Overview

The purpose of this notification is to advise customers of the phased introduction of top marking changes for Xilinx® 7 series, Zynq®-7000, Zynq® UltraScale+™, UltraScale™, and UltraScale+™ commercial / industrial "XC", Automotive "XA", and Defense-grade "XQ" devices. There is no change to fit, form, function, or reliability.

*Figure 1:* Product marking examples

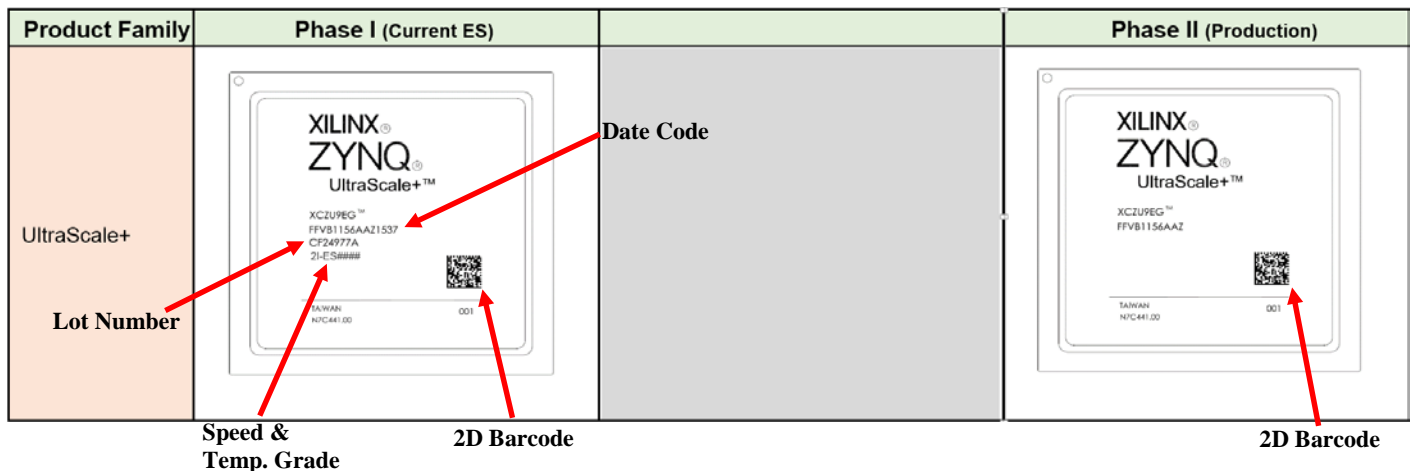
Xilinx will be adding a 2D barcode to the topside marking for all Xilinx 7 series, Zynq-7000, Zynq UltraScale+, UltraScale, and UltraScale+ commercial / industrial "XC", Automotive "XA", and Defense-grade "XQ" devices. The addition of this 2D barcode allows for improved device-level traceability. The change will be introduced in phases as outlined in Table 1 (refer to XTP424 for transition updates).

Through the enhanced device-level traceability provided to customers using the 2D barcode, Xilinx as a 2nd phase will be improving its delivery support and manufacturing scalability by removing selected topside marking information (line 4 speed, temperature grade and SCD information), as indicated in Table 2 and illustrated in Phase II of Figure 1 and Figure 2.

Affected devices are identified by the following package top marks as shown in Figure 1 and Figure 2.

Produt Family	Current	Phase I	Phase II

Speed & Temp. Grade (Current)

Speed & Temp. Grade (Phase I)   2D Barcode (Phase I)

2D Barcode (Phase II)
